# UNITED STATES PATENT AND TRADEMARK OFFICE

APPLICATION NO.	FILING DATE	FIRST NAMED INVENTOR	ATTORNEY DOCKET NO.	CONFIRMATION NO.
10/537,625	06/03/2005	Joanne Joy Smith	1926-00106	5466
26753	7590	07/23/2007		
ANDRUS, SCEALES, STARKE & SAWALL, LLP 100 EAST WISCONSIN AVENUE, SUITE 1100 MILWAUKEE, WI 53202			EXAMINER BARLOW, MONICA L	
			ART UNIT	PAPER NUMBER
			3609	
			MAIL DATE	DELIVERY MODE
			07/23/2007	PAPER

<b>Office Action Summary</b>	Application No.	Applicant(s)	
	10/537,625	SMITH, JOANNE JOY	
	Examiner	Art Unit	
	Monica L. Barlow	3609

## **DETAILED ACTION**

FIG 2

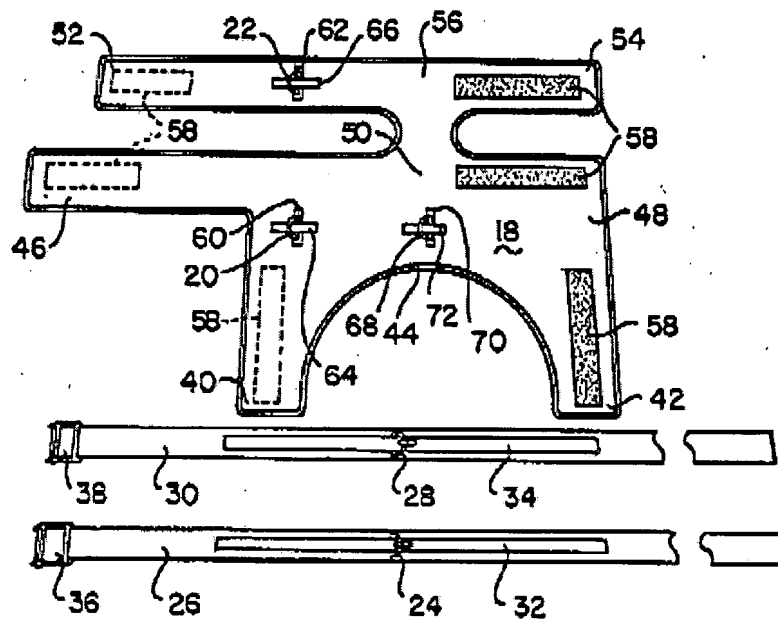
7. In re claim 17, with reference to Figure 2 shown below, Friedman discloses an animal safety restraint for vehicles with a neck strap, a body strap with two fixing points (20, 22) between the chest and spine strap adapted for attachment to a vehicle seat by a pair of linkages (26, 30), each having a first end (24, 28) adapted to engage with a fixing point and a second end (36, 38) adapted for attachment to a seat, a spine strap with a further fixing point and a chest strap both connecting the neck and body strap.

9. In re claims 21-23 and 27, with reference to Figure 2, Friedman discloses the neck strap and the body strap each have two free ends each end having complementary engagement means being a quick release clasp (58) to fasten around the animal's neck and body, where the fixing points are adjacent to the engagement means on the body strap.

10. In re claims 28 and 29, with reference to Figure 2, Friedman discloses each strap of the harness to be adjustable using the engagement means (58).

11. In re claim 31, with reference to Figure 2, Friedman discloses each fixing point is a metal ring.
